July 11, 2013
Mission Chateau
City-Wide Neighborhood meeting

Presentation to the Planning Commission Work Session July 2nd, 2013

Presentation by MVS, LLC of potential design changes in response to Planning Commission and Public comments

MISSION ROAD TRANSITION ZONE

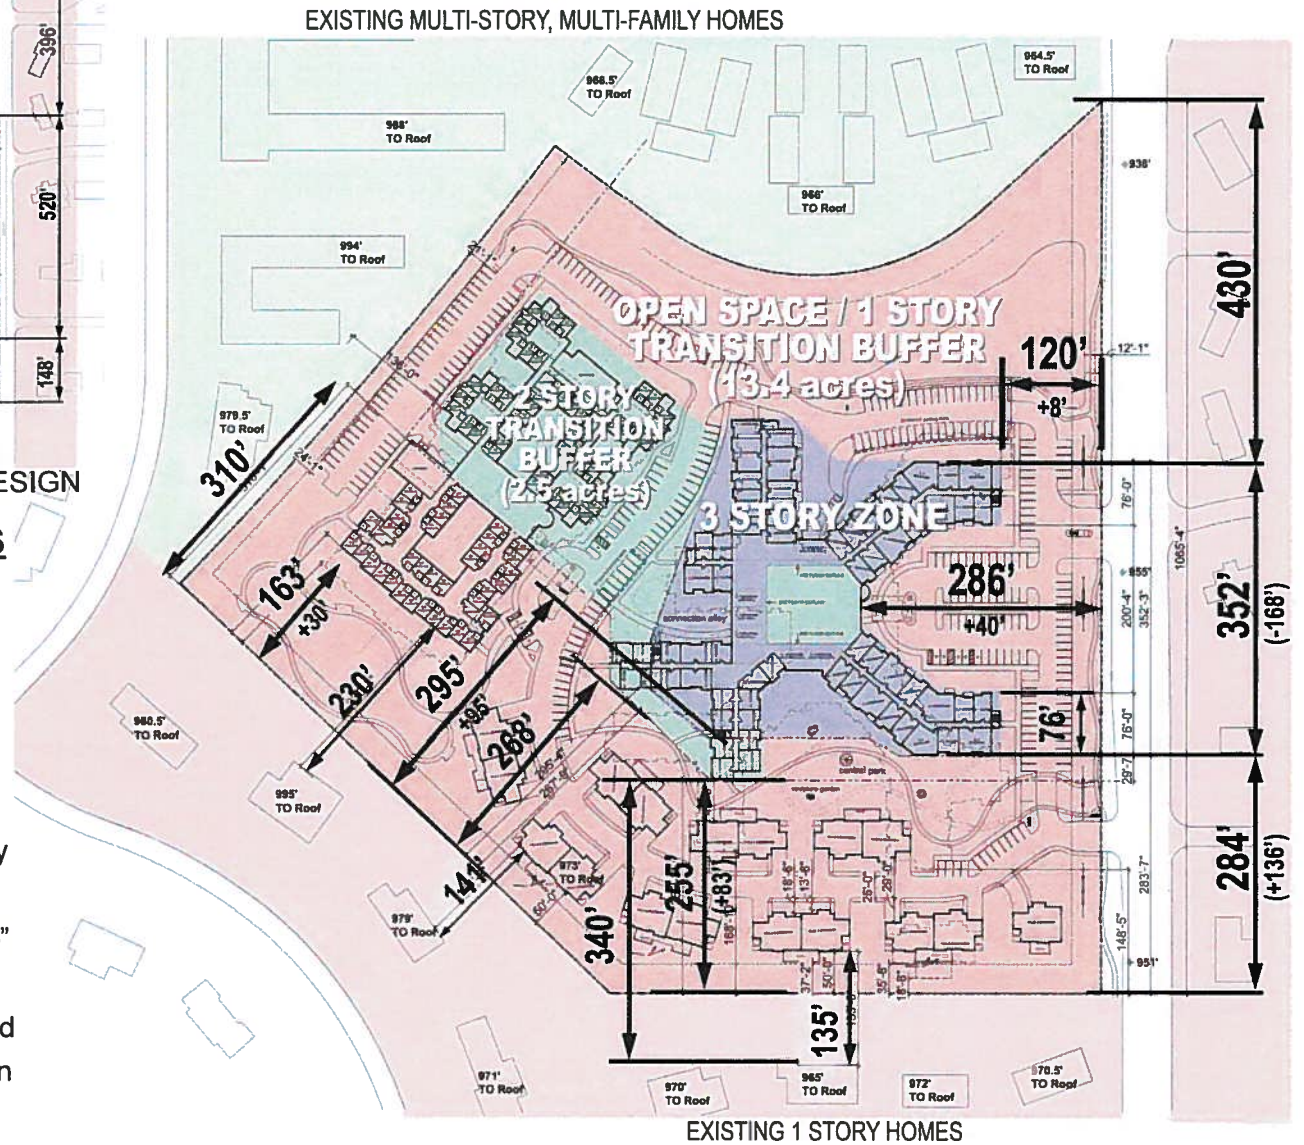
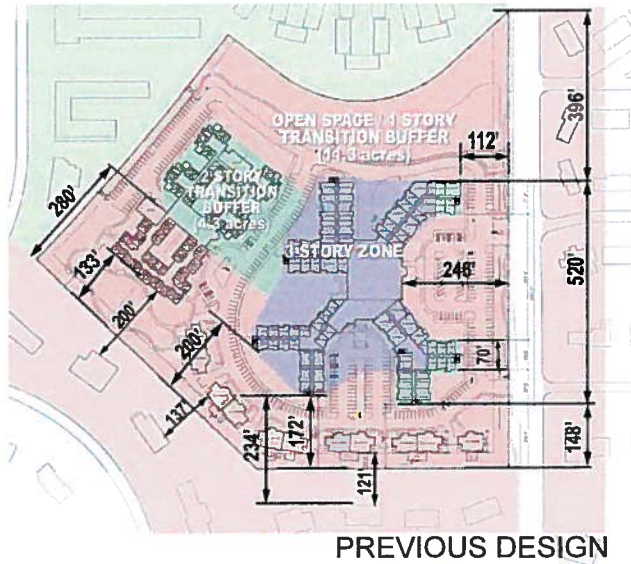
- Mission Chateau is located on a “Transition Site”: efforts should be made to enhance the transition between residential and commercial uses
- The width of the Independent and Assisted Living Facility fronting Mission Road is 520' : efforts should be made to reduce this impact on Mission Road.
- The view of the Independent and Assisted Living facility from the residences to the south should be minimized

1. Reduced frontage from 520' (49%) to 352' (33%)
2. Increased setback from 112' to 120' at the tips (+8')
3. Increased setback from 246' to 286' at the entry (+40')
4. Broke up 3 Story Facade with a 1-story facade at the entry.
5. Improved "Figure Ground Relationship" by creating gap between structures.
6. Gap between wings is 93' narrower and 32' deeper, reducing facade on Mission
7. Preserved 40' wide greenspace on Mission Rd

VILLA'S SETBACK AND TRANSITION ZONE

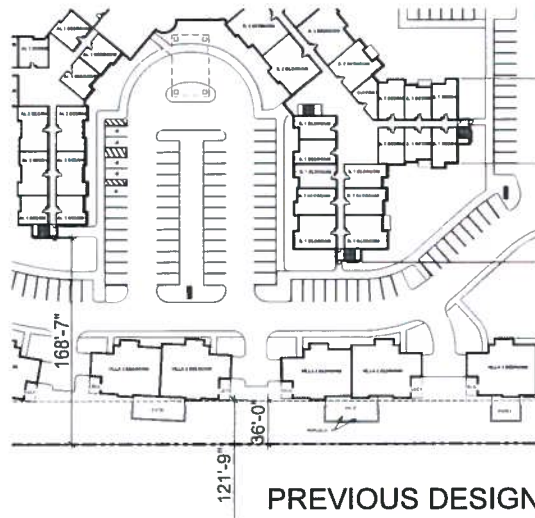
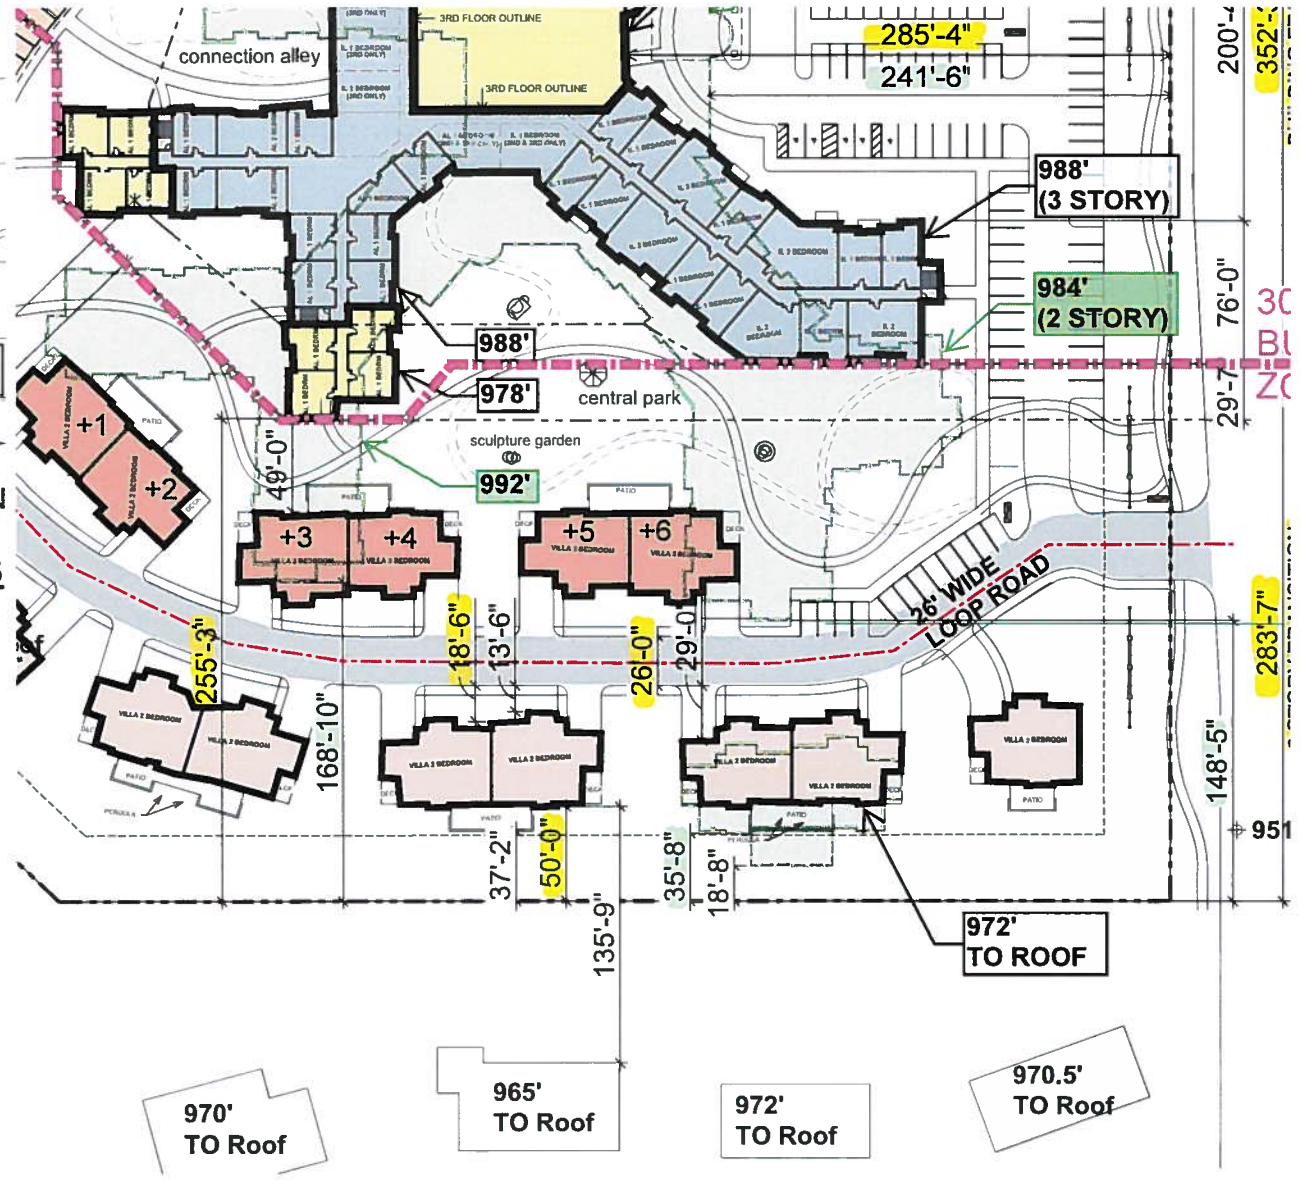
Question: With the buffer on the south you increased the setback from 35 to 50 feet?

- The architecture is attractive but should be more consistent with existing architecture and target towards reducing the appearance of grandeur
- Consideration should be made to increase the width of the interior road
- The relationship of the villas to the single-family houses to the south should be considered, specifically the front and rear yard setbacks
- Consider the height in relationship to adjacent properties

Response: The villas were originally proposed at a 35 foot setback that also had a patio included within the setback. The new proposal is to have the villas constructed at a 50 foot setback from the property line and move the patios to the side of each home so that it is no longer within the setback. We stated at the Planning Commission meeting that there is also an additional 7 feet of space that has been provided in the front yard of the villas that could be moved to the back side of the villas, if desired and we would like to know your preference on that.

1. Created a traditional neighborhood street with Villas
2. Increased rear yard setback from 35' to 50' (+15')
3. Moved patios off the 35' setback
4. Increased front yard from 5' (avg.) to 16' (avg.) (+11')
5. Moved driveway and garage access to the front of the villa
6. Created green side yard and eliminated headlight impact
7. Northern Villas offset to further screen the view from the South
